Re: Consultation on an Application

Planning Application Ref: PL/25/1853

Address: 255-257 , Whitley Wood Road, Reading, RG2 8LE

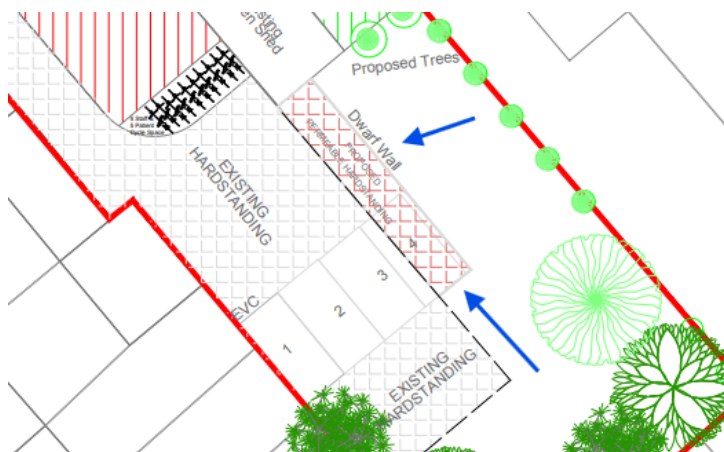
There are many elements of the Proposed Block Plan, 1st December 2025, Drawing No. WR-04, that are unclear as they are not labelled. The existing structures do not appear to be truly accurate when compared with an aerial image from Google – see below. The garden shed shown in the Block Plan is shown in your site photographs, however the other structures aren't plotted.

Whilst the tree planting shown is positive, I am unclear who will take responsibility for the tree maintenance, given this is outside of the flat's amenity area and outside the boundary of no. 257. There also appears to be a structure which conflicts with the proposed tree

planting – see annotated Proposed Block Plan and Google extracts below. I am unclear why the proposed flat's amenity is so limited, when the current site of no. 257 has a large rear garden. It is unclear who will take responsibility for the remaining area of rear garden once this house has been converted.

With the site of no. 255 almost entirely hard surfaced, further hard surfacing should be resisted. Further hard surfacing is proposed, to provide further car parking spaces (parking space 4 – see below); however, the parking arrangements shown in the Proposed Block Plan aren't representative of that appearing on Google either. It is assumed the dwarf wall is to separate the car park of no. 255 and rear garden on no. 257, but clarity should be sought on this as the change in boundaries/boundary treatment is not clear.
